### APPEAL SUMMARY

**Appeal ID:** 20220

**Project Address:** 1410 NW Johnson St

# 1410 NW JOHNSON STREET

36  
A3.1 ENLARGED FIRST FLOOR EXIT LOBBY  
SCALE: 1/4" = 1'-0"

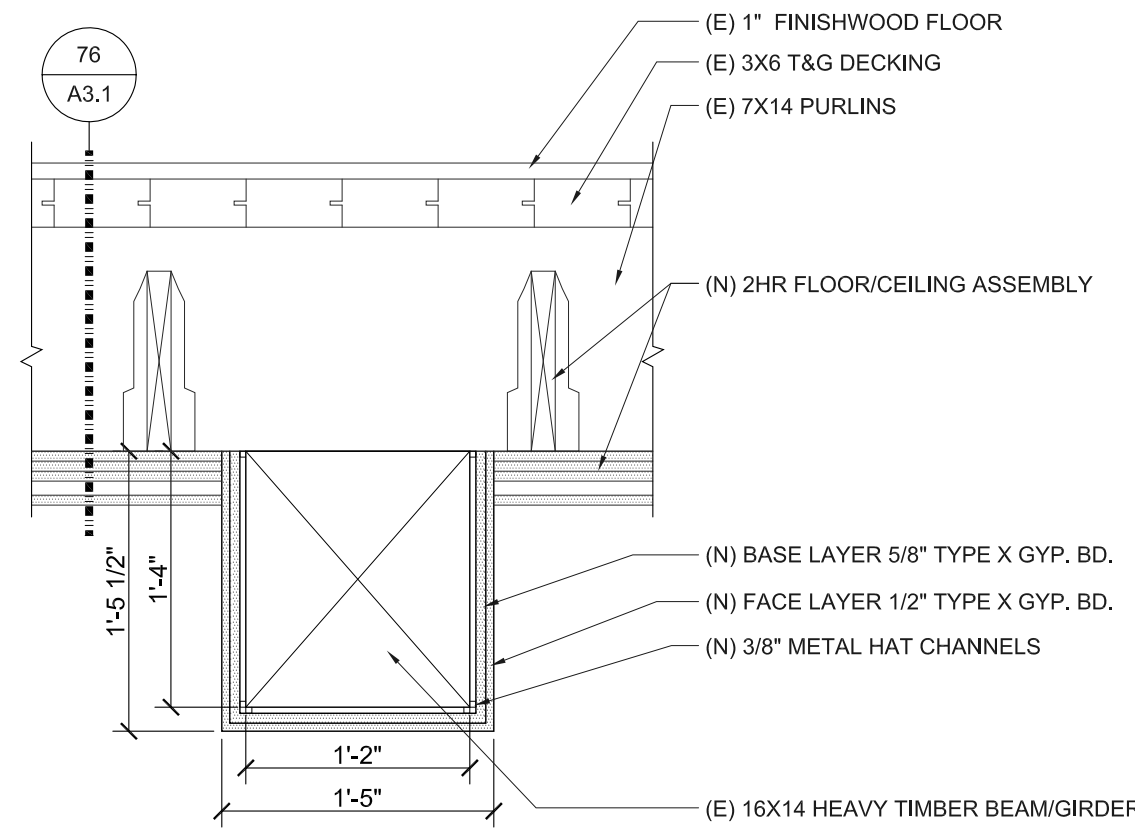
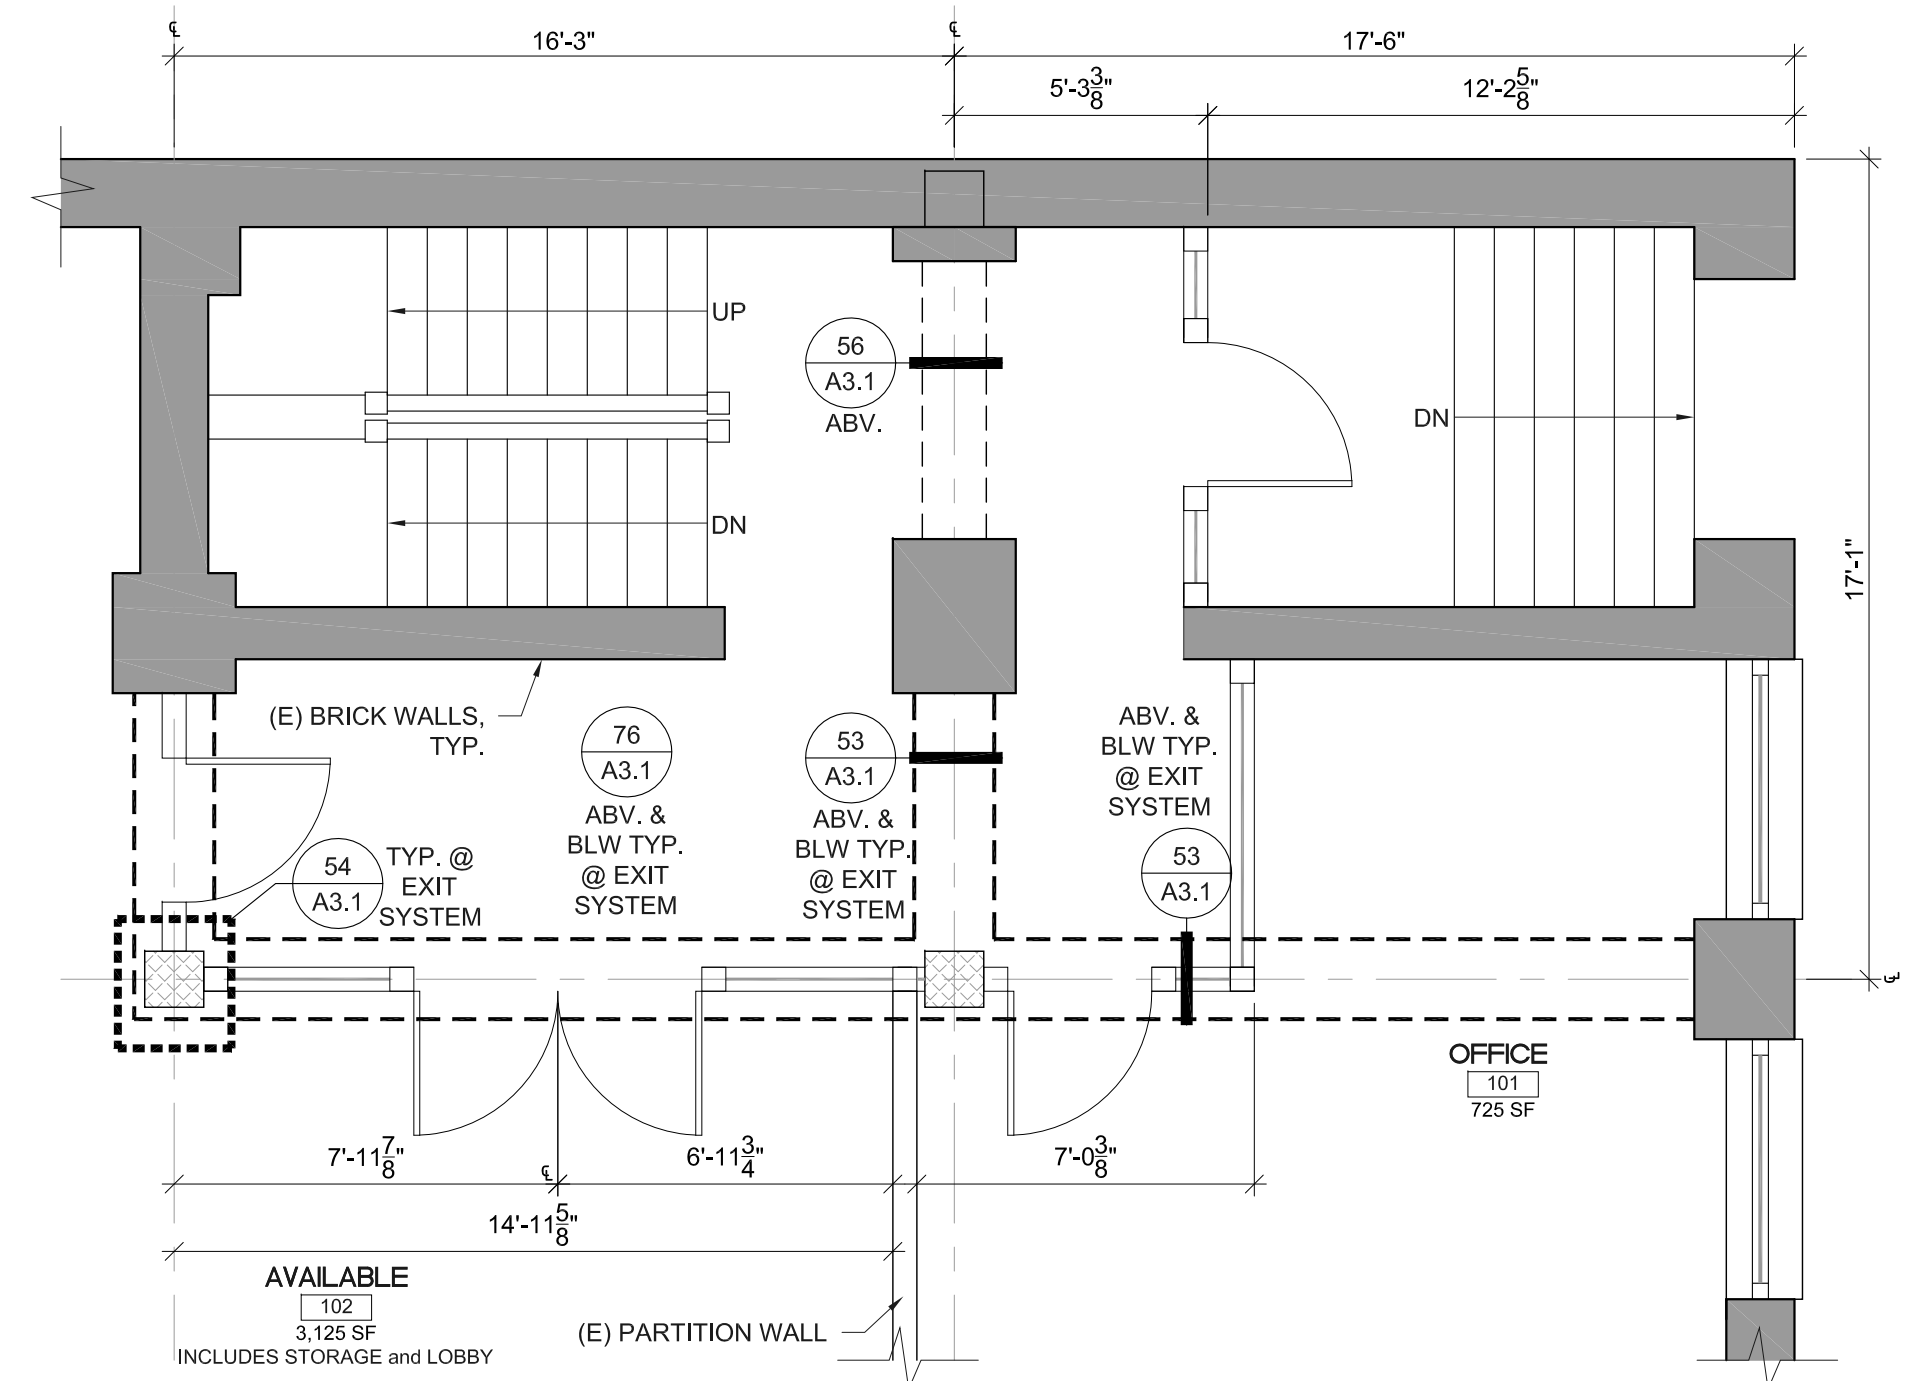
Where non-rated interior glass relite and doors are used, a 2HR rated fire curtain is provided (Tyco Model WS – 2HR Fire Barrier).

RESPONSE: A Building Code appeal is required for substituting 2HR fire curtains in lieu of two-hour fire resistive construction.

**Extension of stair enclosures: Hold for additional information.**  
**Appellant may contact Corey Stanley (971 291-8919) with questions.**
